MEMORANDUM

**RE: Planning Commission Hearing of August 23, 2021
Brandon Sullivan et al Appeal of the Sasan Site Plan Review Approval
Agenda Item: 4**

Sasan Site Plan Review

P3073

Figure 2. Site layout showing two lots consisting of three parcels.

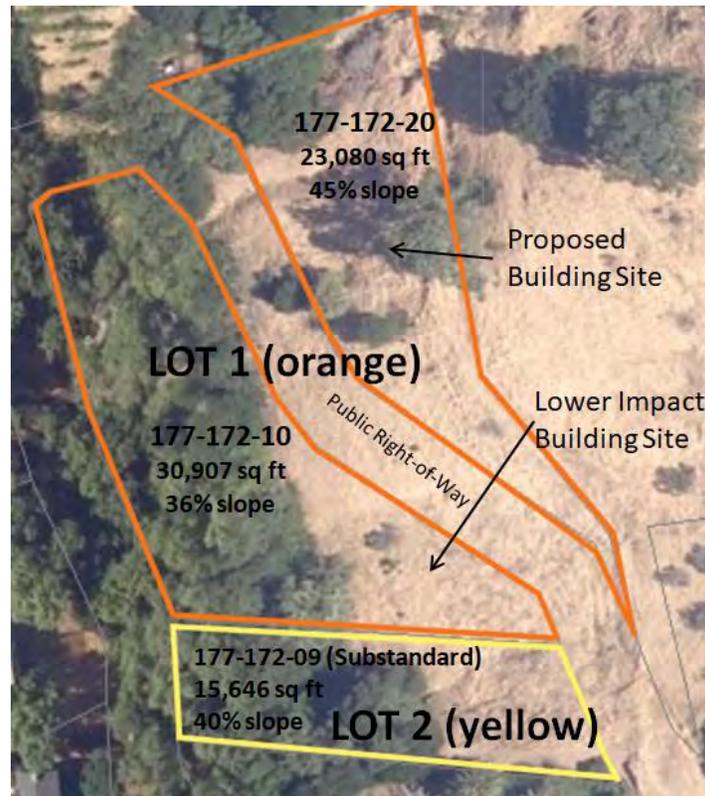
Figure 2 below shows Lot 1 (orange) is divided into two parcels by the public right-of-way. Even though there are two parcels, only one house can be constructed on this lot in its current configuration. Lot 2 is a substandard lot because it is “at least 50 percent smaller in total area than required for new parcels under the applicable zoning district or slope regulations, in compliance with Section 22.82.050 (Hillside Subdivision Design Standards), whichever is more restrictive” (MCDC Section 22.42.020). Under Hillside Subdivision Design Standards, for lots that have a slope of 40% or greater, the minimum lot area is 43,560 sq. ft. Since this lot is only 15,646 sq. ft. with a slope of 40%, it is more than 50% smaller than the minimum required lot area of 43,560 sq. ft., and therefore is substandard.

2021 FCS Site Map. Proposed house is in the SCA as measured from the edge of the riparian canopy (yellow line).

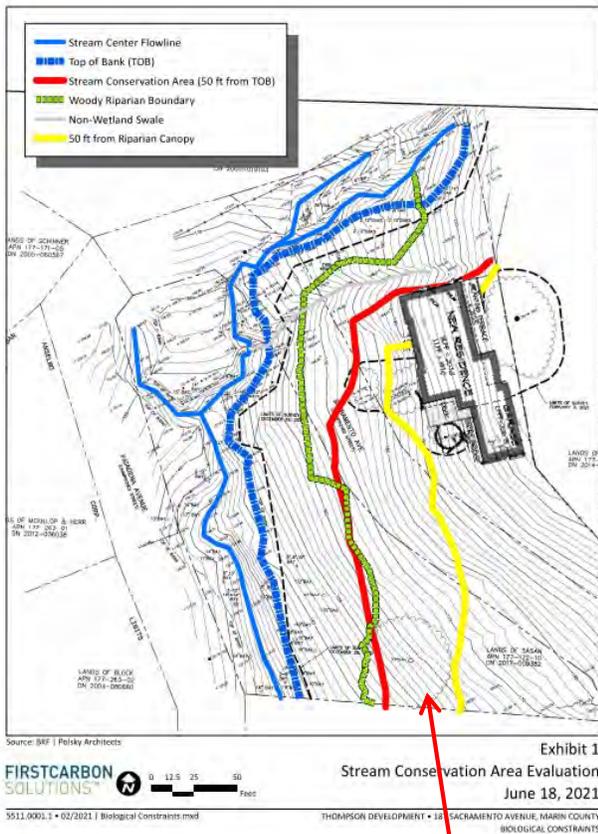
Biological constraints maps show the proposed house is located in the SCA as measured from the riparian canopy.

Exaggerated tree canopy makes the buildable area of this parcel look smaller than it actually is.

Building footprint encroaches into Tree Protection Zones (TPZs)

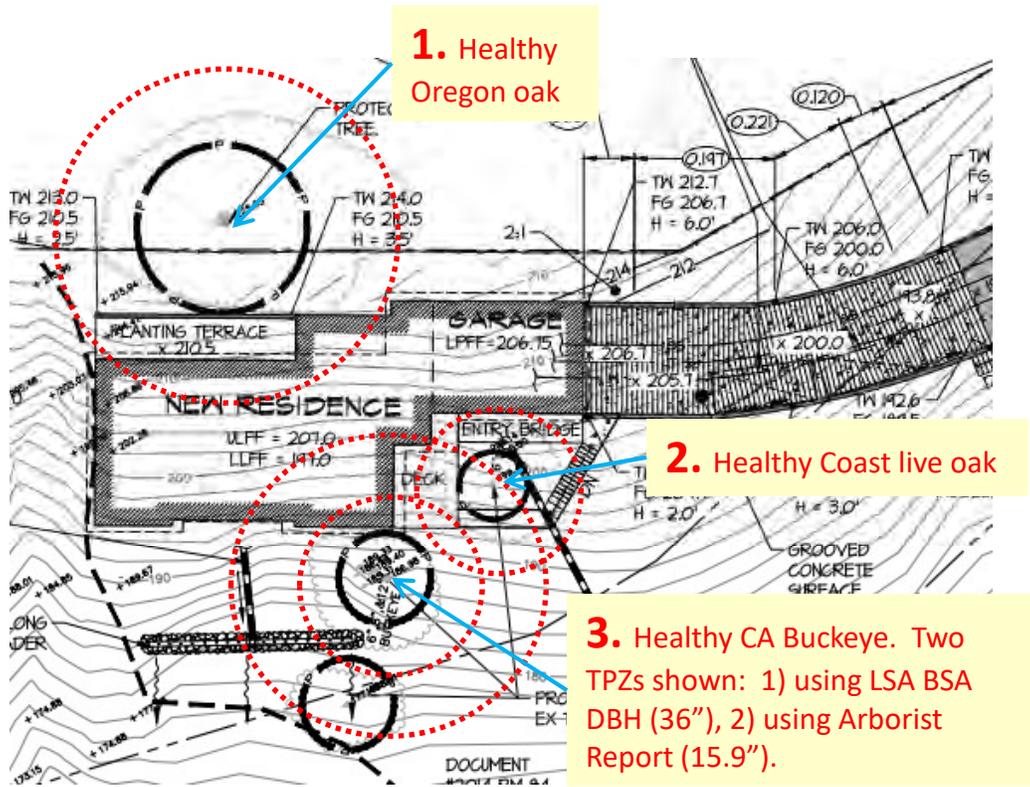
If Tree Protection Zones (TPZs) are accurately drawn using DBH as directed in the 2019 BSA (red dotted circles), the building footprint encroaches into TPZs. Encroachment would be even more severe if current tree sizes were used rather than measurements made 3 years ago.

Tree canopy size per MarinMap aerial photograph as compared to FCS Biological Constraints Map

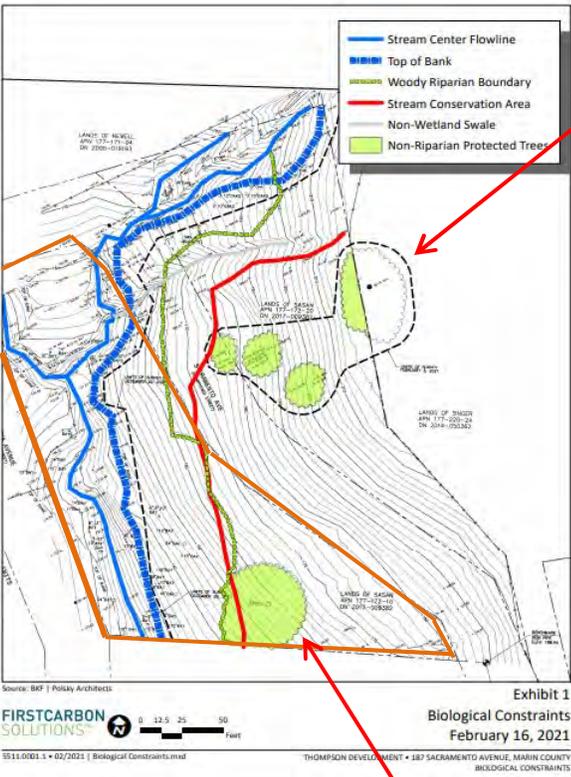
This comparison shows that there is much more space for a house below the public right-of-way than what's represented in the FCS map (left), which overstates the canopy size of the unhealthy oak growing along the southern boundary. It also shows that there is much less space for a house in the proposed location because the applicants have ignored how the canopy is actually growing.

Canopy of healthy Oregon oak growing along eastern boundary. The site map does not accurately show the extent to which the oak canopy overlaps the building site. The canopy shape is not oval as sketched on the site map.

Canopy of unhealthy Oregon oak growing along southern boundary. Note that the canopy is exaggerated in the drawing as compared to the aerial photograph. Also note that the unhealthy oak canopy is drawn about the same size as the healthy oak canopy. Clearly this is not the case.

Encroachment of House into the Stream Conservation Area

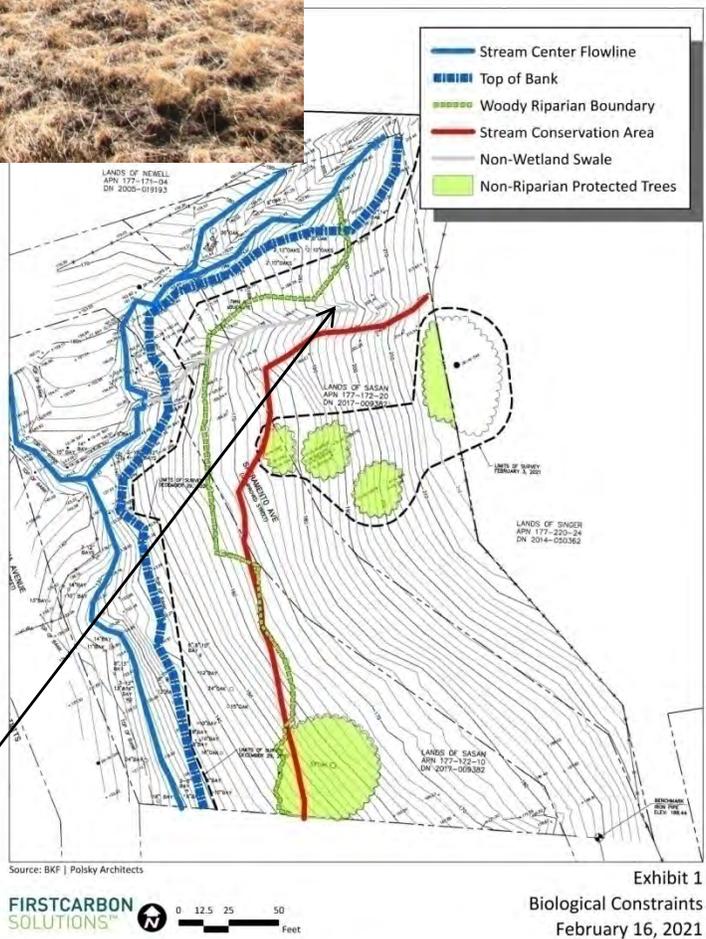
Stakes #39, 40, 41 were located in the “non-wetland swale” indicated by a gray line on the FCS map until they were recently moved to the south when neighbors pointed out their location was in the SCA. Given the self-admitted “errors” and “confusion” on the part of the applicants, we are not confident the house fits onto this building site.

Figure 1. Site Layout and Building Locations.

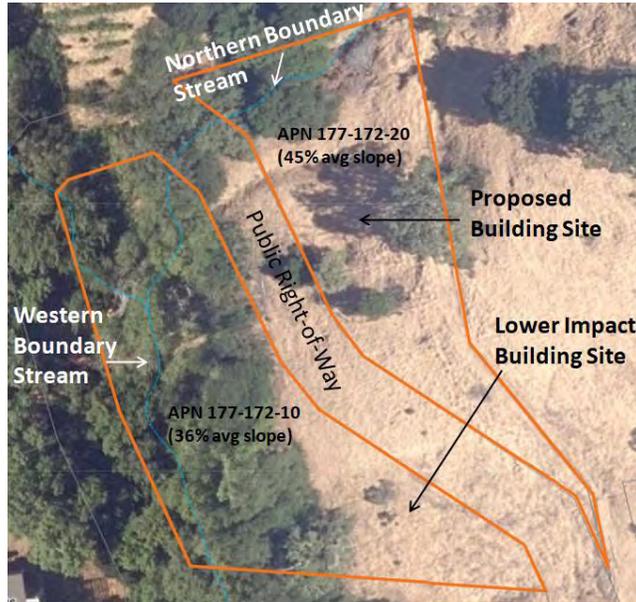
In 2017, we reached out to the applicants to propose a lower impact building location, closer to the developed end of Sacramento avenue and at a lower elevation [below the public right-of-way] that greatly reduces the amount of grading required for road construction and diminishes the visual impact to neighboring homes. Better siting of the home lower on the hillside avoids forcing it into unstable areas of the property in very close proximity to protected native trees and streams. Unfortunately, the applicants continue to propose development on the steepest, most exposed area of the lot, at the most distant point from the developed end of Sacramento Avenue, and in close proximity to a cluster of protected native trees. Figure 1 provides an overview of the site.
